2000 & LATER DODGE TRUCKS & VANS

INTERNAL LINKAGE AND SAFETY NEUTRAL SWITCH CHANGES

Figure 1

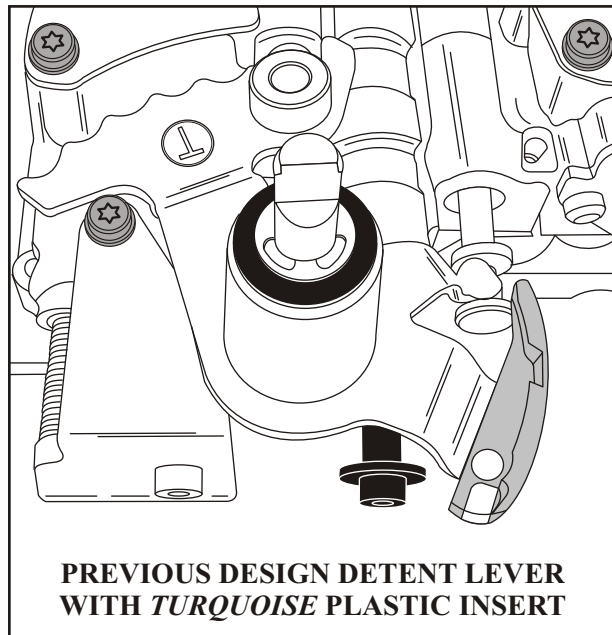
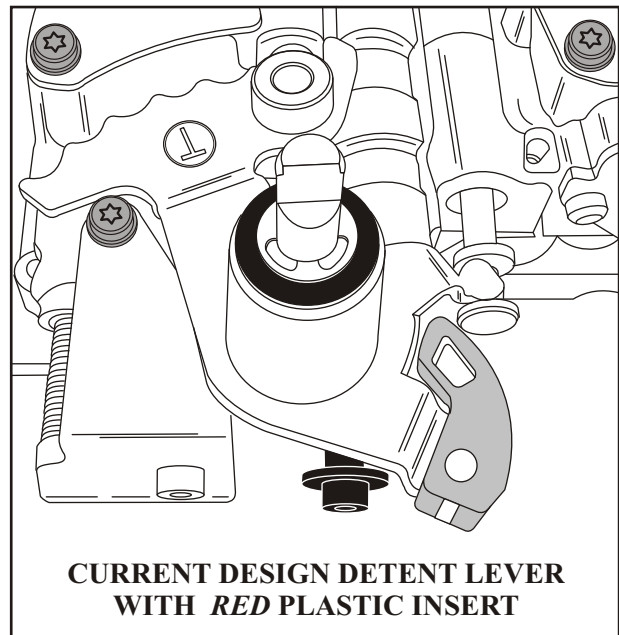
COMPLAINT: After a valve body exchange, the vehicle does not start or the detent lever cannot clear the safety neutral switch.

CAUSE: The safety neutral switch and the valve body detent lever changed for the 2000 model year. The switch is longer and the detent lever dimensionally changed to accommodate the new switch. Figures 1 and 2 show the dimensional differences between the previous and current design detent levers. Figures 3 and 4 illustrate the correct and incorrect assembly using the short switch. Figure 5 shows the correct assembly using the long switch.

CORRECTION: The detent lever with the **red** plastic insert goes with the **long** safety neutral switch. The detent lever with the **turquoise** plastic insert goes with the **short** safety neutral switch.
